**HUDSON RIVER PCBs SITE  
REASSESSMENT RI/FS  
SCIENTIFIC AND TECHNICAL COMMITTEE  
TUESDAY, AUGUST 18, 1998  
ALBANY, NEW YORK**

**MEETING MINUTES**

# **Low Resolution Sediment Coring Report**

# SENSITIVITY OF BERYLLIUM-7 DETECTION TO DECAY RATE AND ANALYSIS DATE

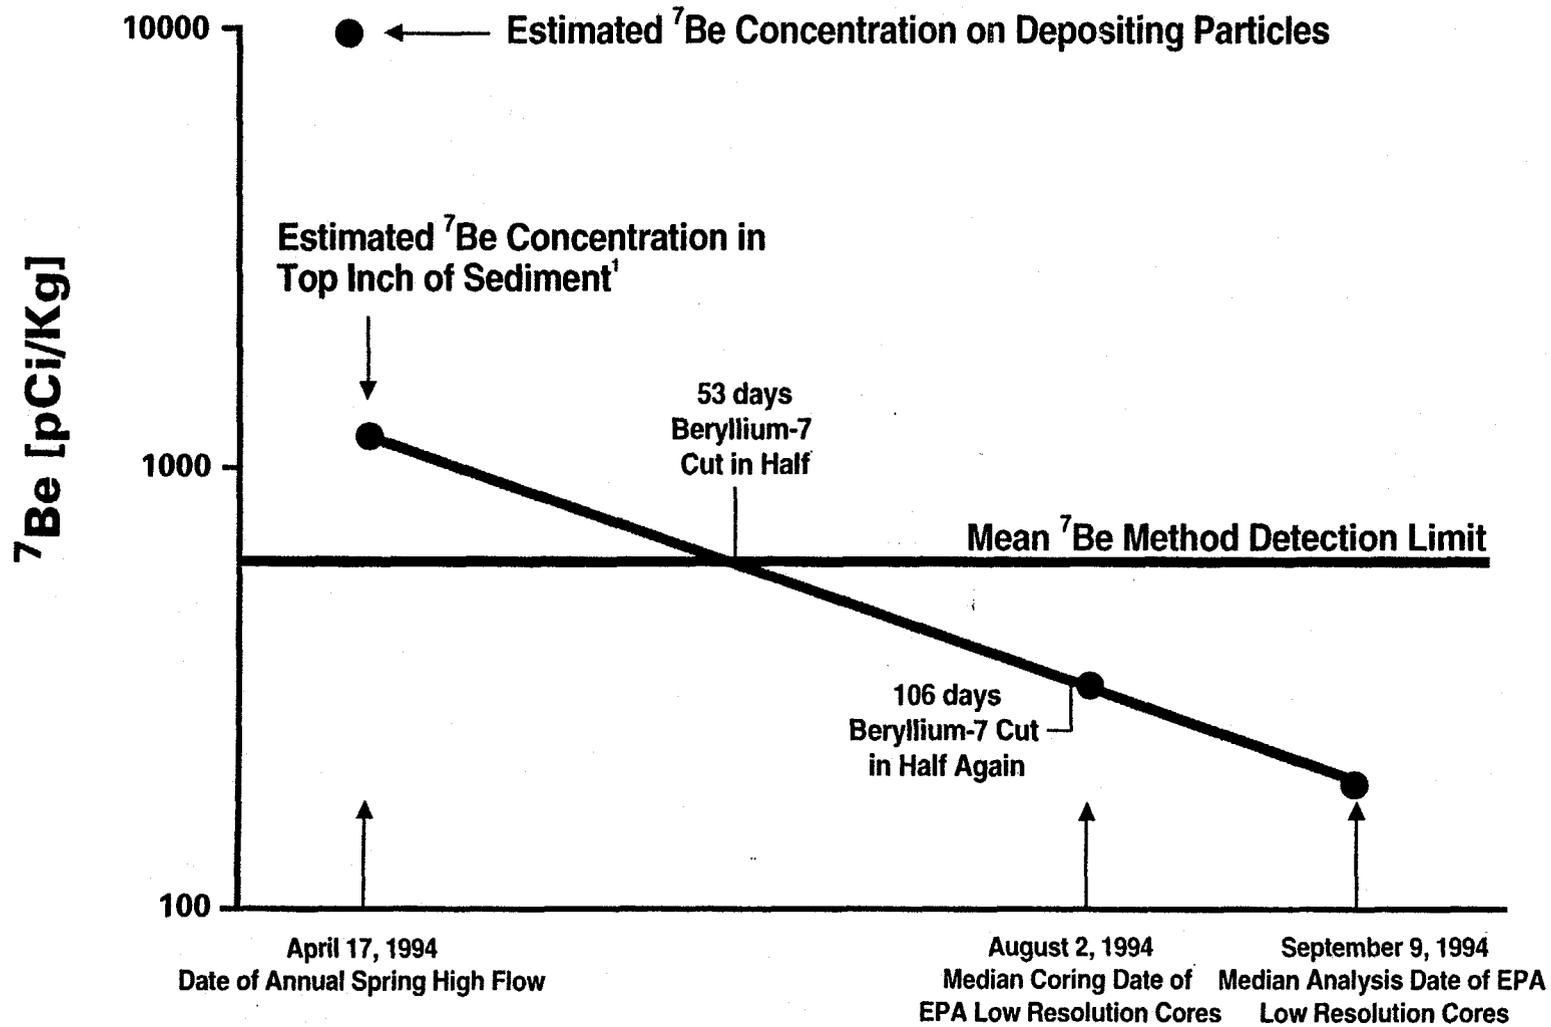
**CONCLUSION:** The absence of Beryllium-7 does not mean an absence of burial.

# CONCENTRATION OF PCBs AT VARIOUS SEDIMENT DEPTHS

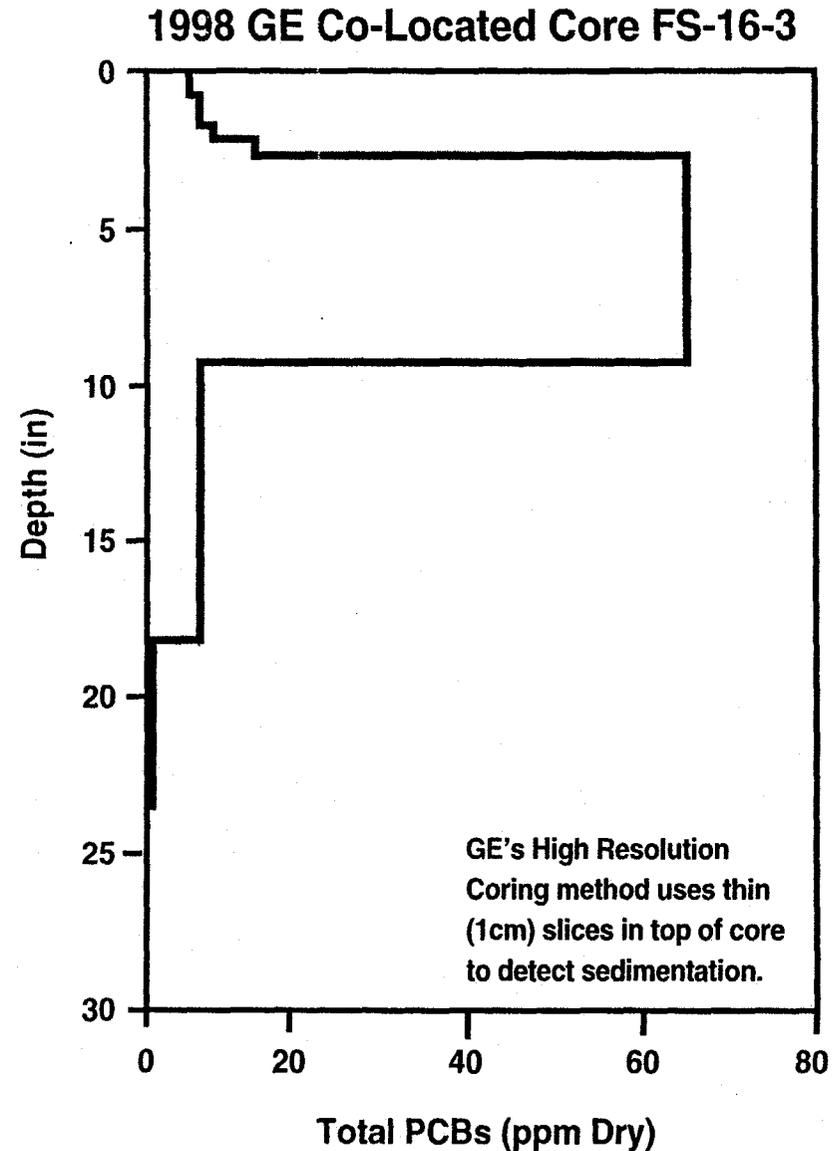
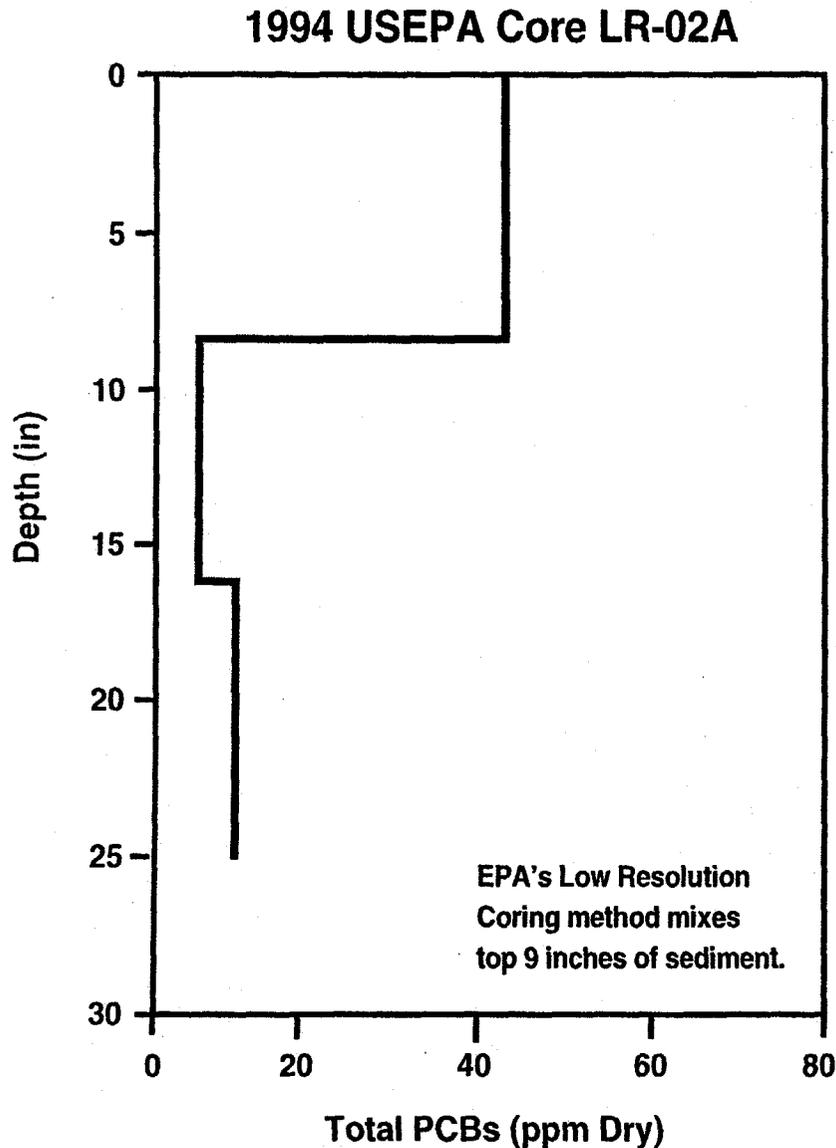
- EPA's analysis also suffered because it compared results from two different and incompatible sampling techniques — the equivalent of comparing apples to oranges. Approximately half of EPA's 1994 core samples were collected five feet or farther away from the original sample location — too far for a valid comparison in an area where conditions change dramatically over very short distances — or drawn from "grab samples" (scoops of mud) rather than the 1984 "core samples" (long tubes of mud). Had EPA compared apples to apples, the results would show that EPA's claim of a 40 percent loss of PCB inventory was highly exaggerated.

# PCBs IN SEDIMENT CORES COLLECTED AT SAME LOCATIONS IN 1998 AND 1994

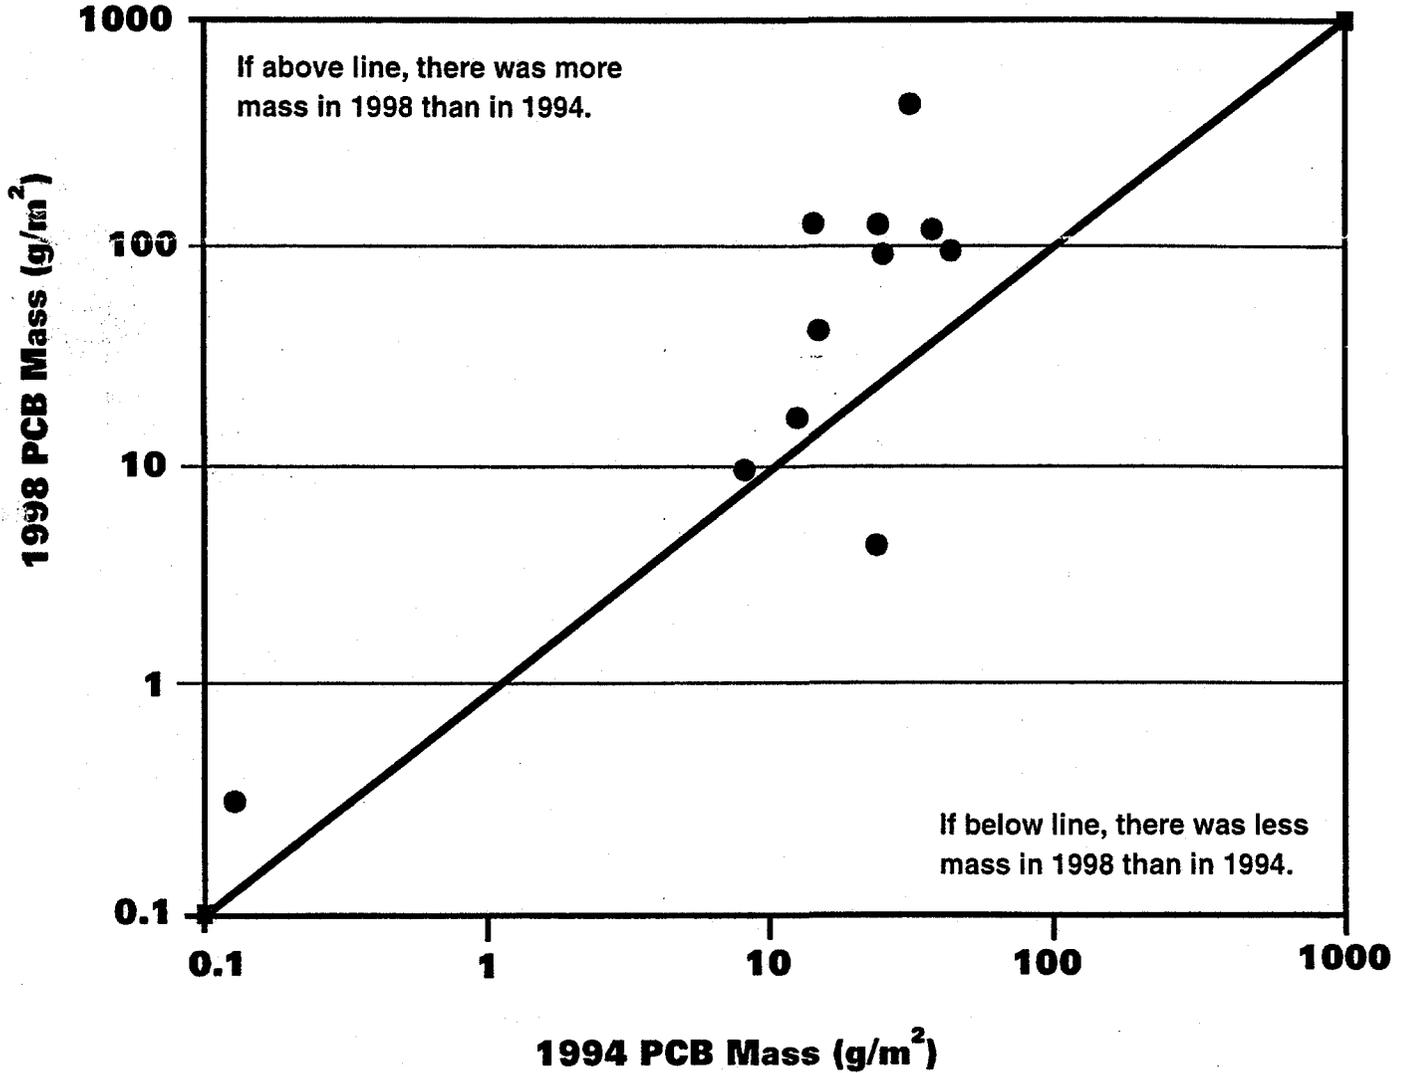
**CONCLUSION:** EPA's 1994 mass estimates are biased low and overestimate the mass loss between 1984 and 1994.
